MANATEE COUNTY

SUBJECT: Invitation for Bid #12-1310-OV
SWWRF Lake Filtration System and North Pond Improvements
Bradenton, FL, Manatee County Project No.: 6079180

ADDENDUM #4

Attached memorandum dated June 4, 2012 from McKim & Creed is issued to respond to questions received from Contractors at the Pre-Bid / Information Conference held on April 30, 2012 and questions received via email from Contractors. (14 Total Pages)

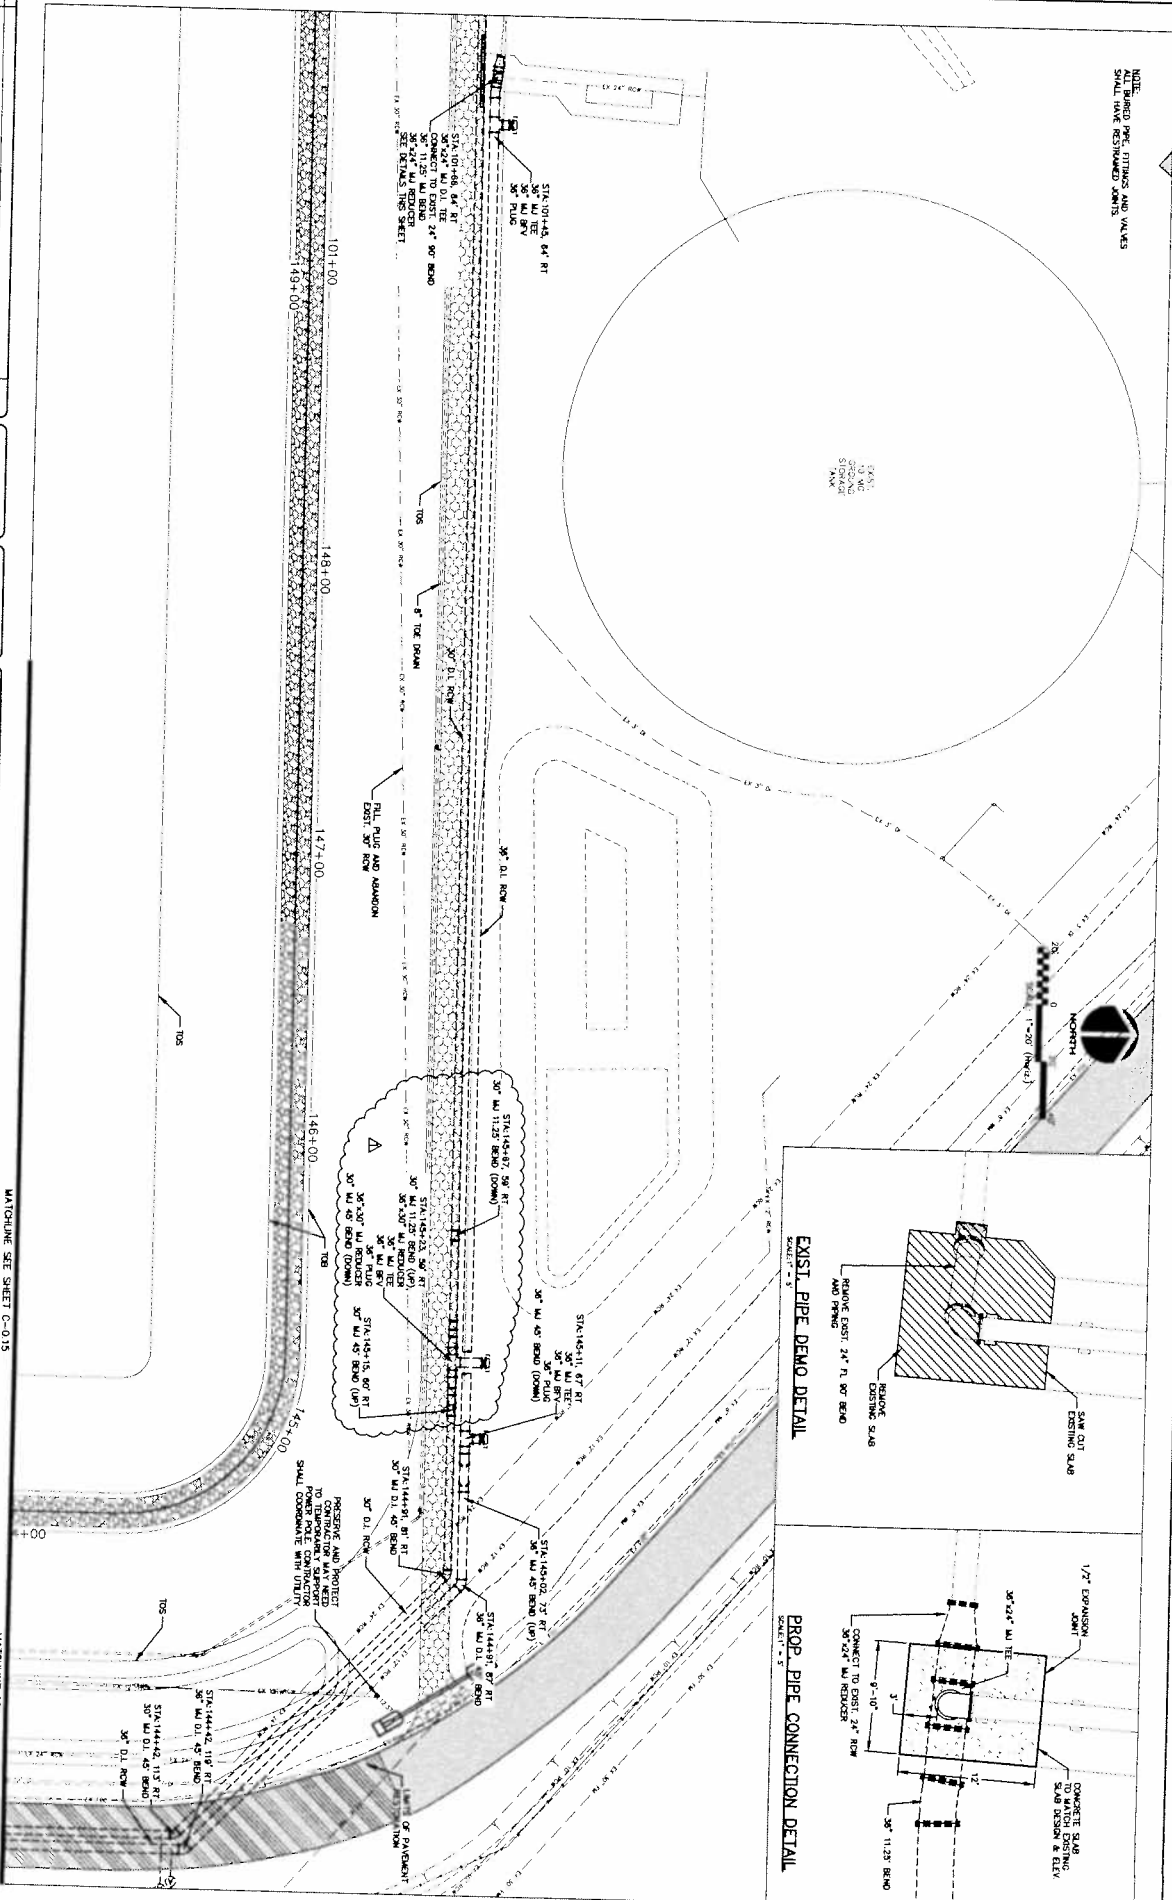
1. SHEET C-0.2 PROPOSED SITE PLAN AND SOIL EROSION AND SEDIMENTATION CONTROL: Remove Sheet C-0.2 of the Contract Drawings and replace with the attached Sheet C-0.2, Revision 1.

DRAWING NUMBER
C-1.18

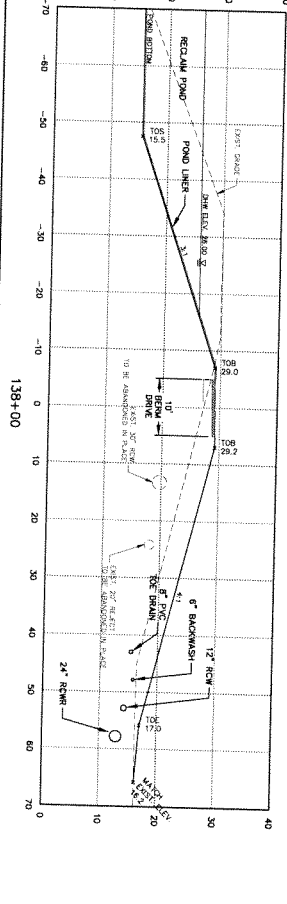
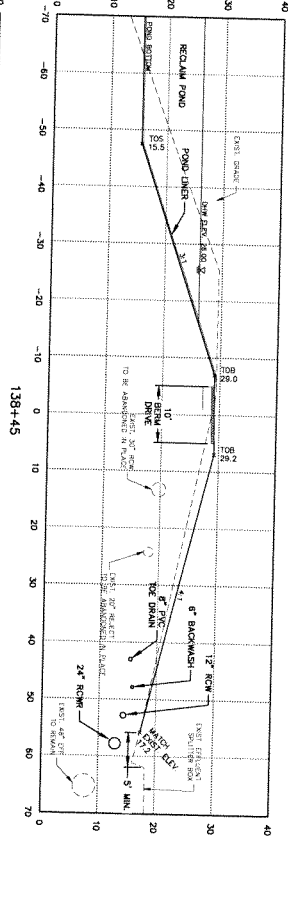
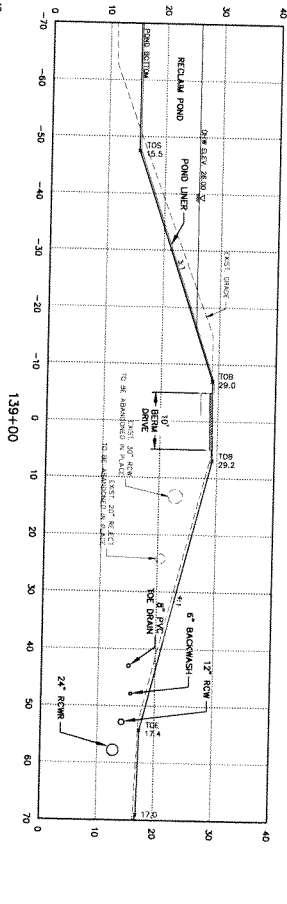
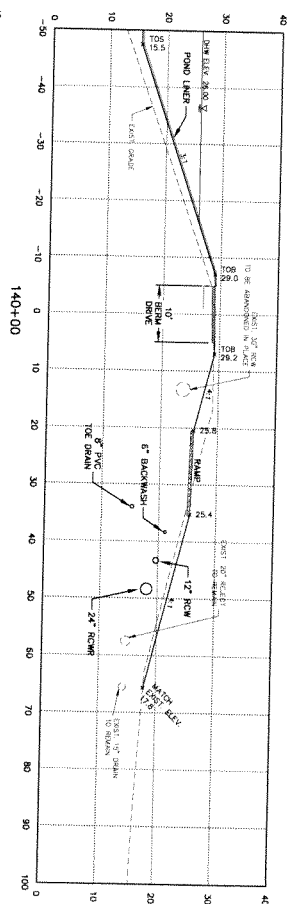
4. SHEET C-1.18 POND SECTIONS No. 6: Remove Sheet C-1.18 of the Contract Drawings and replace with the attached Sheet C-1.18, Revision 1.
5. SHEET S-1.2 GRAVITY DISK FILTER FOUNDATION PLAN, SECTIONS AND DETAILS: Aluminum Ladder assembly similar to Section 11.S-2.2. Space the 3/8" bent plate support brackets at 4'-0" o.c. (max.).

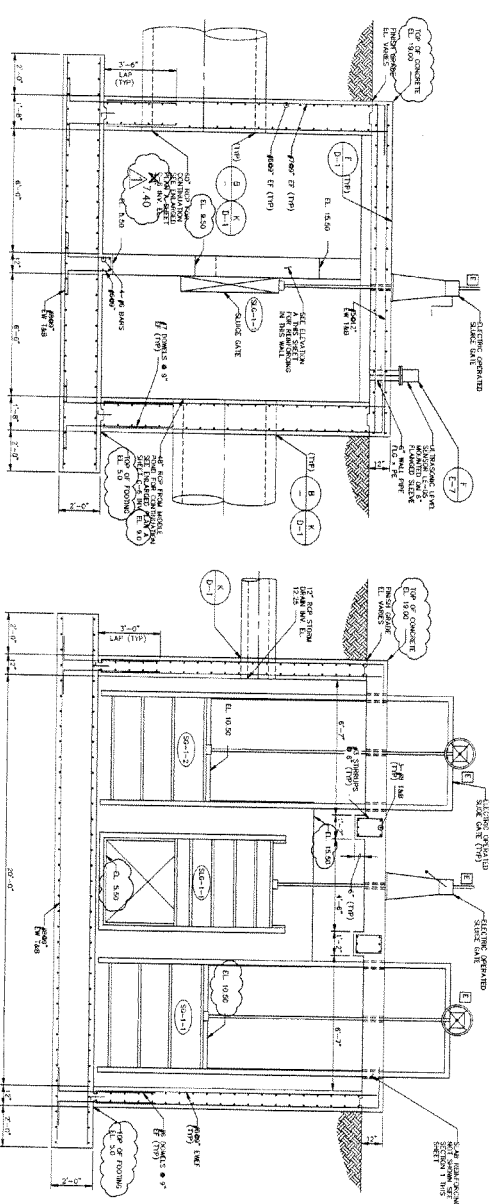
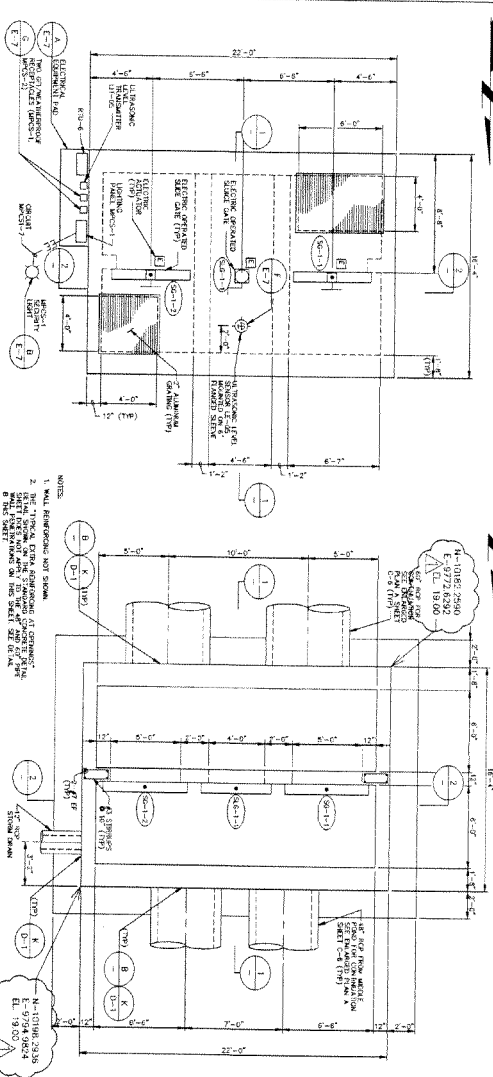
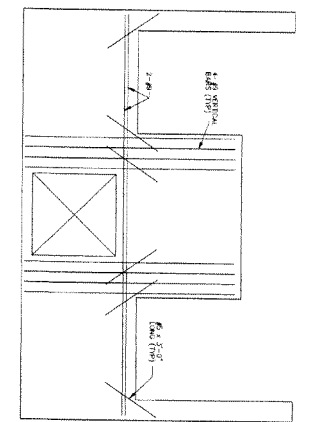
4. Question: Please provide a detail of the Middle Pond Gate Structure that will show a cross section from north to south in addition to the east to west cross section provided on Sheet C-0.7. The structure has a concrete wall above the top of the structure and the SG are located in the center of the structure. Is there an existing concrete wall inside the structure that the SG are mounted to?

5. Question: How many influent and effluent pipes are connected to the Middle Pond Gate Structure and what size and type are they?

Response: See Record Drawing Sheet M-5 Middle Pond Control Structure Plan And Sections dated 3/18/02 attached.

Response: See Record Drawing Sheet M-5 Middle Pond Control Structure Plan And Sections dated 3/18/02 attached.

REINFORCING AT 48" AND 60" PIPE
WALL PENETRATIONS DETAIL
1/8" = 1'-0"

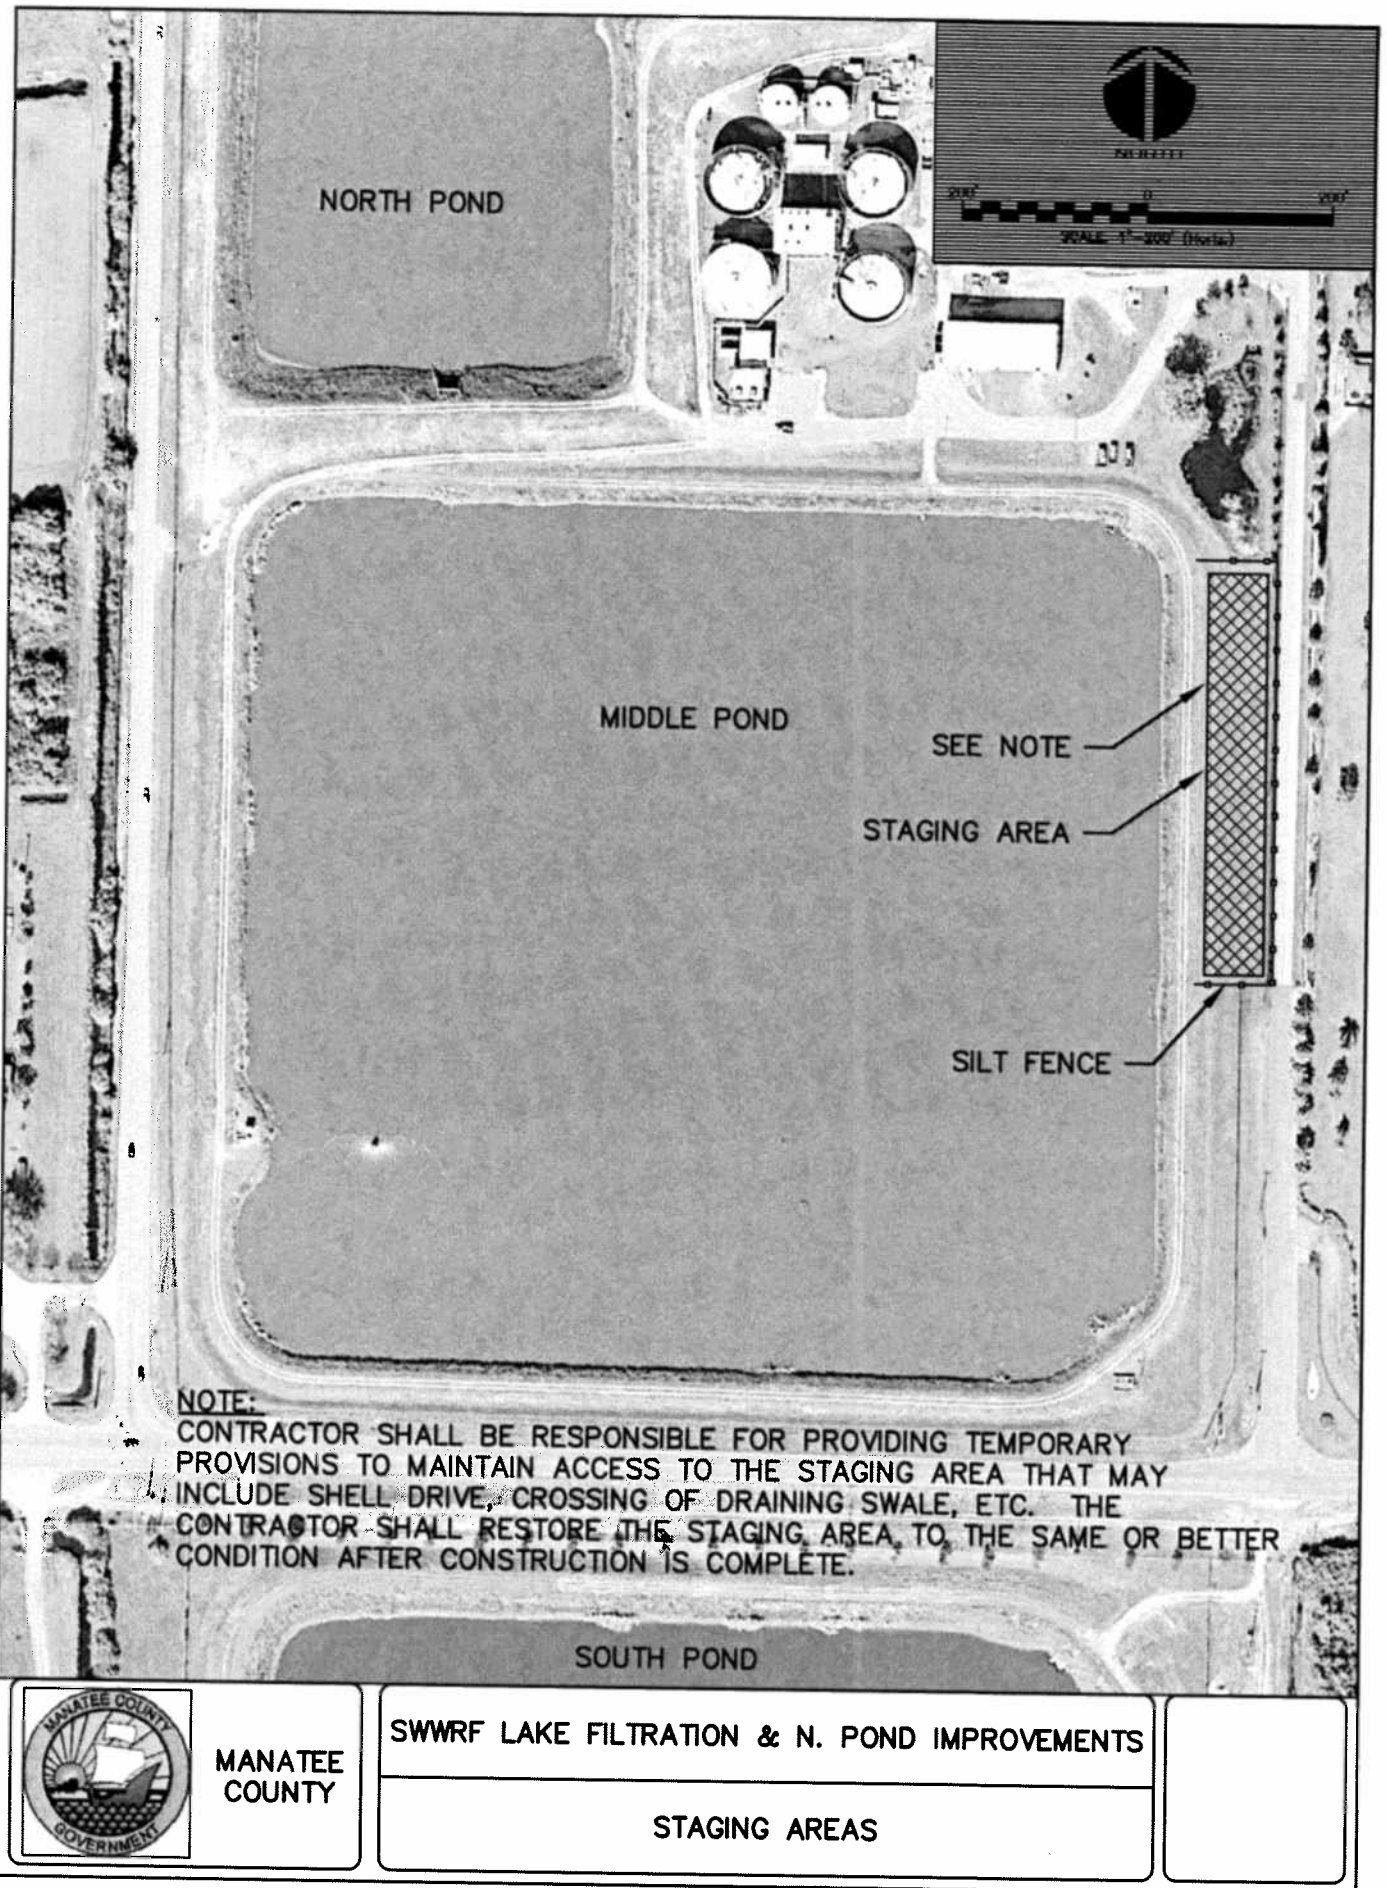
- Section 2.S-3.1 space the #4 "z"-bars at 1'-4" o.c.
 - Reference SK-S5 for reinforcing around pipe penetrations through the slab-on-grade.
 10. SHEET S-5.1 EFFLUENT PUMP STATION PLAN, SECTIONS AND DETAILS:

SECTION A/M-4.4
SCALE: 3/8" = 1'-0"

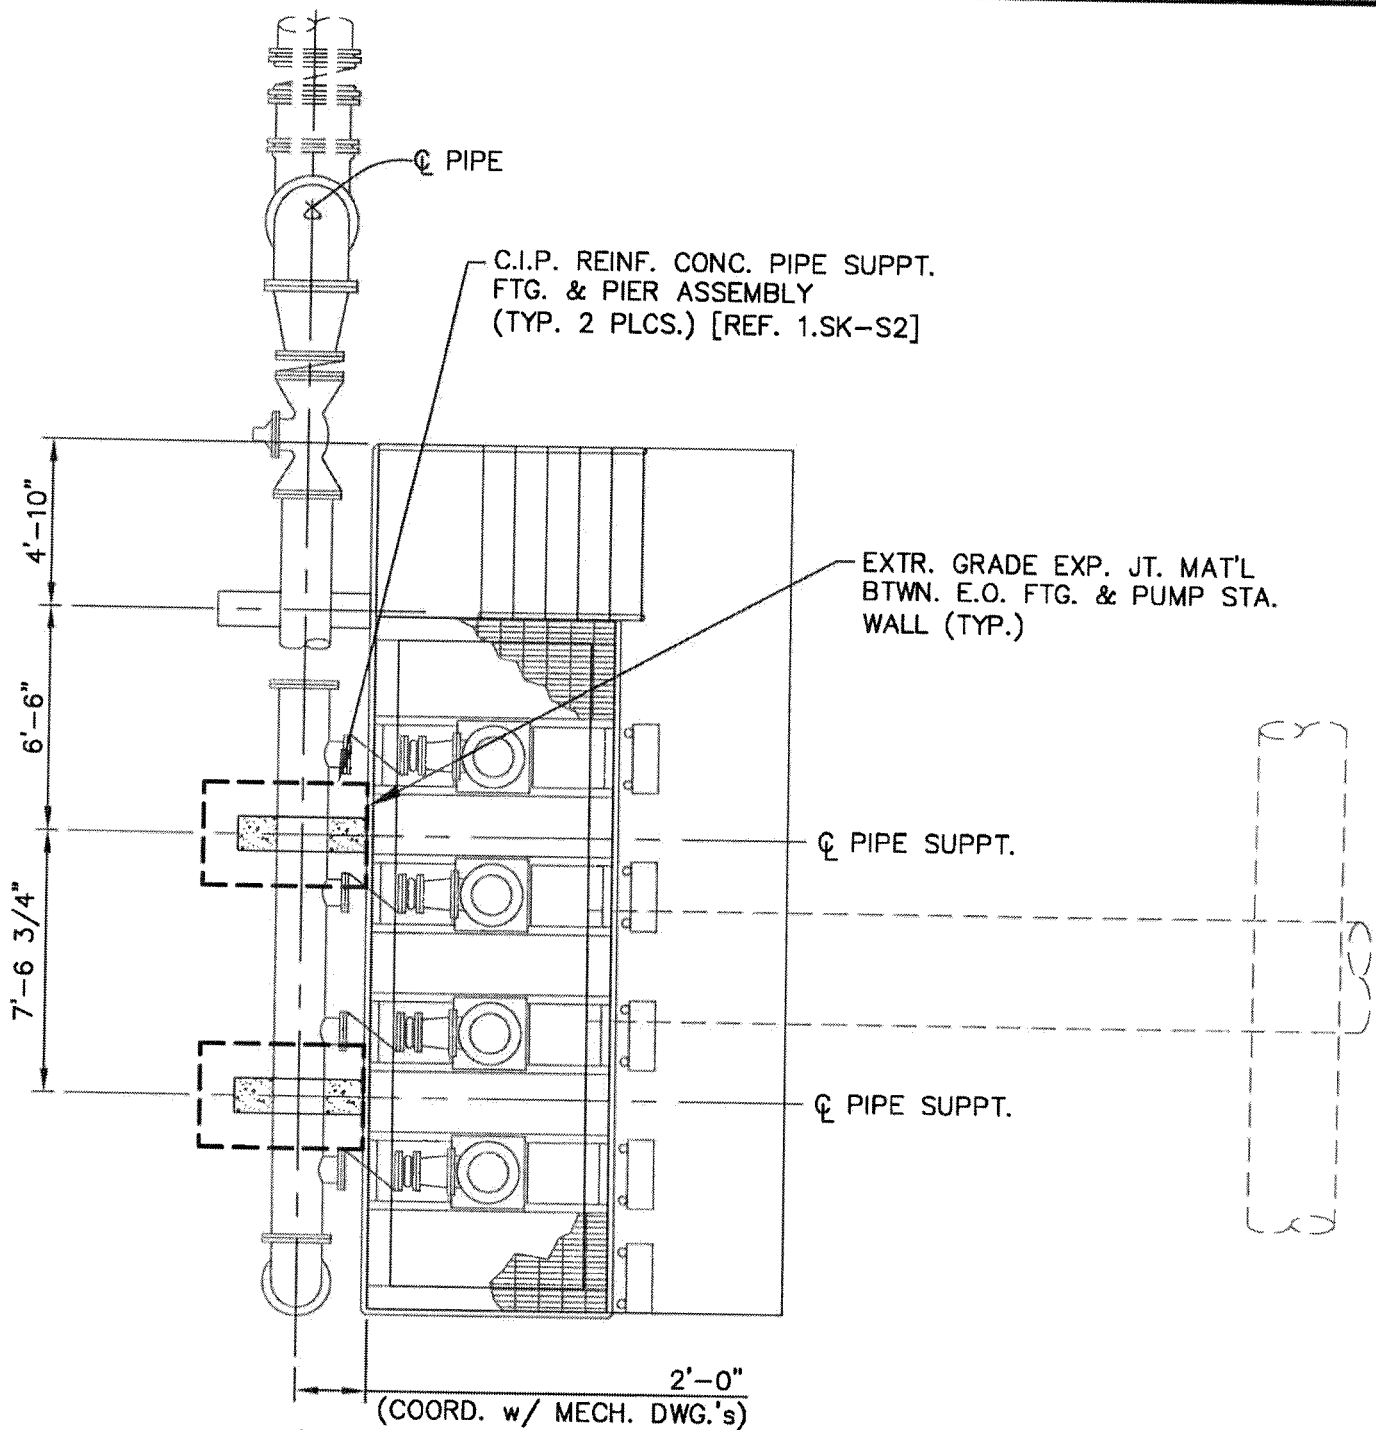
23. Question: Can limits of supply be clearly defined for the Unfiltered PS pumps and 16" Header with Supports stated on Drawing M-4.4?

24. Question: Spec section 15100-5 and drawing M-4.4. Are the four 8" FL Check Valves located at the Unfiltered Pump Station new valves and are they to be provided under this contract? Will these valves be air cushioned swing type check valves at this location too? Please clarify the meter size.

- Section 2.S-5.1 space the #4 "z"-bars at 1'-4" o.c.
 - Reference SK-S5 for reinforcing around pipe penetrations through the slab-on-grade.
 11. SHEET M-4.4 UNFILTERED PUMP STATION: Remove Sheet M-4.4 of the Contract Drawings and replace with the attached Sheet M-4.4, Revision 1.

Response: The Owner will supply five (5) vertical turbine pumps with motors, columns, bowls and support frames, five (5) combo starter panels and one (1) 16-inch multiport header shown at centerline elevation 23.13.

Response: Supply four (4) 8-inch FL air cushioned swing check valves in accordance with Section 15100. The transient time strap on meter to be supplied by the Contractor will be installed on a 16-inches diameter DIP in accordance with Sheet M-4.4.
